Addendum 03

PROJECT: Cedar Cliff Schools Connector Addition and Renovation
194 Walnut St
Cedarville, Ohio 45314

PROJECT #: 25056.00

This addendum form is a part of the Contract Documents and modifies the Construction Documents dated June 24, 2026, with amendments and additions noted below.

SHEET TITLE:
**OVERALL
TECHNOLOGY
CABLING AND
EQUIPMENT PLAN**

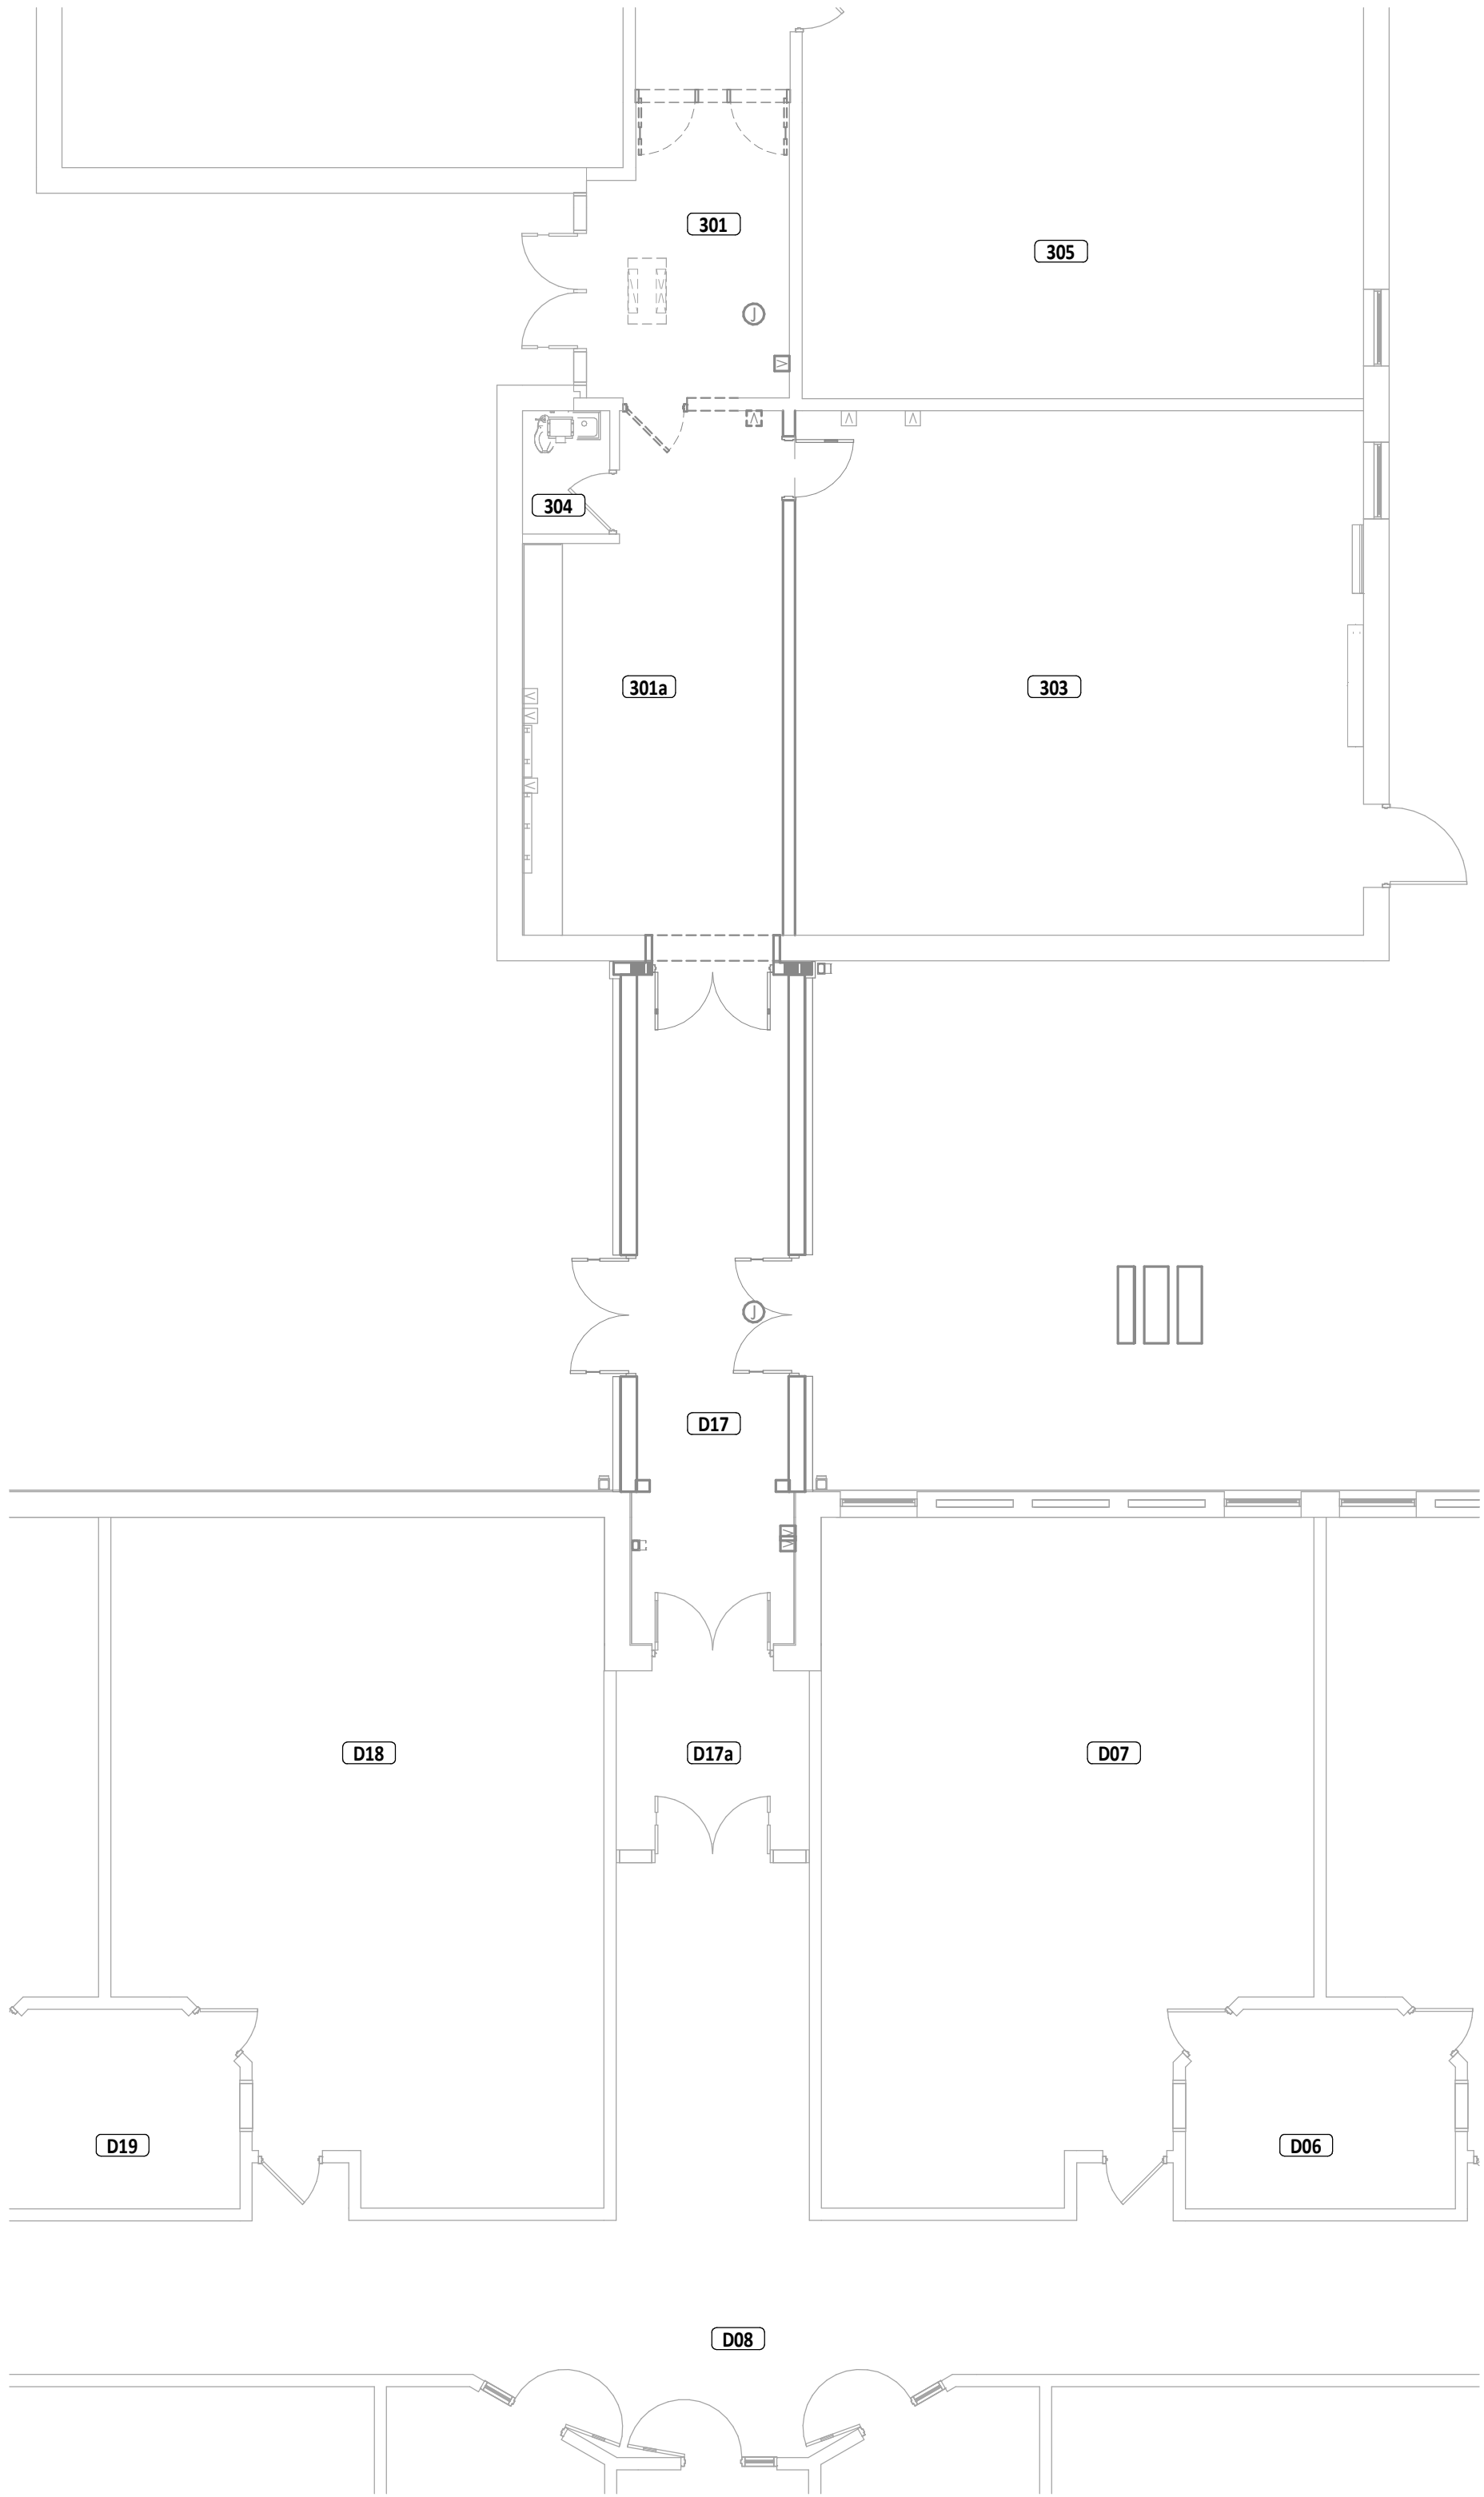
5. Drawing Sheet TCE1.1 OVERALL TECHNOLOGY CABLING AND EQUIPMENT PLAN:
 - a. Remove Detail 3 and Keynote 01.
